# Intel<sup>®</sup> DBPXA250 and DBPXA210 Development Platform for Intel<sup>®</sup> Personal Internet Client Architecture

Specification Update

*July 2002*

Order Number: **278555-002**

Figure 4. LCD Picture 2

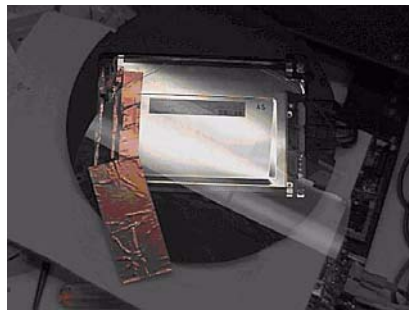
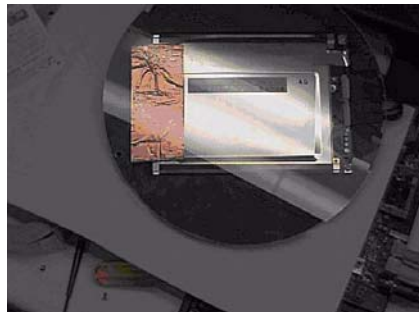
**Problem:** LCD screen is open to excessive noise disruption on the touch screen.

**Implication:** Excessive noise disruption reduces LCD screen display quality. The touch screen may not work correctly.

**Workaround:** Fix this problem by covering the back light inverter with copper foil shielding tape to decrease the electrical noise transferred to the LCD and Touch Screen.

1. Disassemble the BBPXA2xx development baseboard touch screen enclosure.
2. Remove the back light inverter.
3. Cut a piece of heat shrink tubing (1"x3") and place over the inverter.
4. Heat the tubing until it collapses on the inverter.
5. Cut a 2"x5" piece of copper tape and place on clear plastic disk covering the inverter. The adhesive side should face the plastic.
6. Cut a 2"x5" piece of copper tape and place on the black plastic disk under the inverter. The adhesive side should face the back of the LCD metal enclosure.
7. Reassemble the touch screen enclosure.

**Figure 6. R9 Pad to C29**

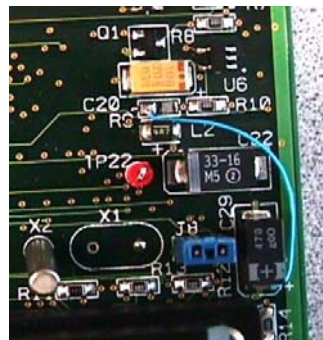
**Problem:** The Intel® PXA250 and PXA210 Application Processors Developer's Manual states VCC\_PLL requires VCC\_CORE voltage instead of a separate voltage supply.

**Implication:** The PXA250 processor may not work if VCC\_PLL is not equal to VCC\_CORE.

1. Remove R9.
2. Add a 30-AWG wire from the R9 pad (inductor L2 side) to the positive side of C29. This can be done on the top of the board.

**Figure 7. Wire From The J3-3 To The Via Of U1 Pin 1**

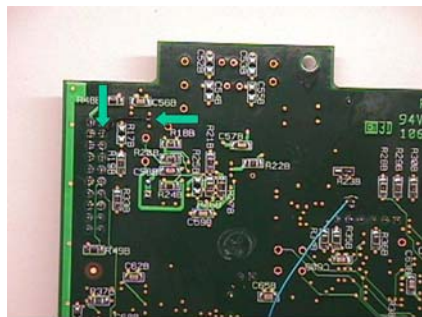
**Problem:** JTAG connection fails when using ARM Multi-ICE tools.

**Implication:** No JTAG debugging facility is available with ARM Multi-ICE.

1. Cut the trace on the top of the processor card between U1 pin 3 and via to the right.
2. Add 30-AWG wire from the J3-3 to the via of U1 pin 1 on the bottom of the processor card.

3. Add a 30-AWG wire from J3-2 to +3.3 V.

**Figure 9. Voltage Divider**

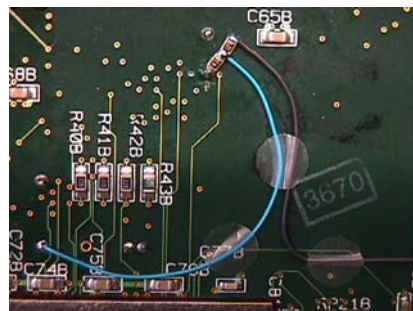
**Problem:** On systems using an oscillator to drive PEXTAL, the 3.3 V output from the oscillator is too high.

**Implication:** Possible damage to chip.

**Note:** These steps bring the oscillator voltage down to 1.1 V. The oscillator and core voltages need to be equal.

1. Attach one side of a 430-ohm resistor to the bottom (on the bottom of the processor card) of TP19 (ground).
2. Attach a 30-AWG wire from the remaining side of the 430-ohm to crystal X1 (The pin closest to the edge of the board).
3. Attach one side of a 620-ohm resistor to the junction of the wire and the 430-ohm resistor. The two resistors will “sandwich” the wire going to X1.
4. Attach another 30-AWG wire from the +3.3 V oscillator output (bottom of U7) to the open end of the 620-ohm resistor.

**Figure 11. U10B Trace Cut Pin 38**

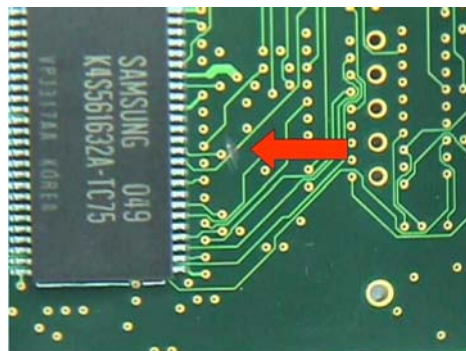
**Problem:** Signal integrity problems on SDCLK.

**Implication:** Unstable operation with 100-MHz SDCLK.

1. Cut the trace exiting U10B, pin 38 on the bottom of the DCPXA250 processor card.
2. Update CPLD U4 with latest code. Refer to <http://developer.intel.com> for latest CPLD updates. This adjusts the voltage (VCC) from +1.2 V to +1.4 V.
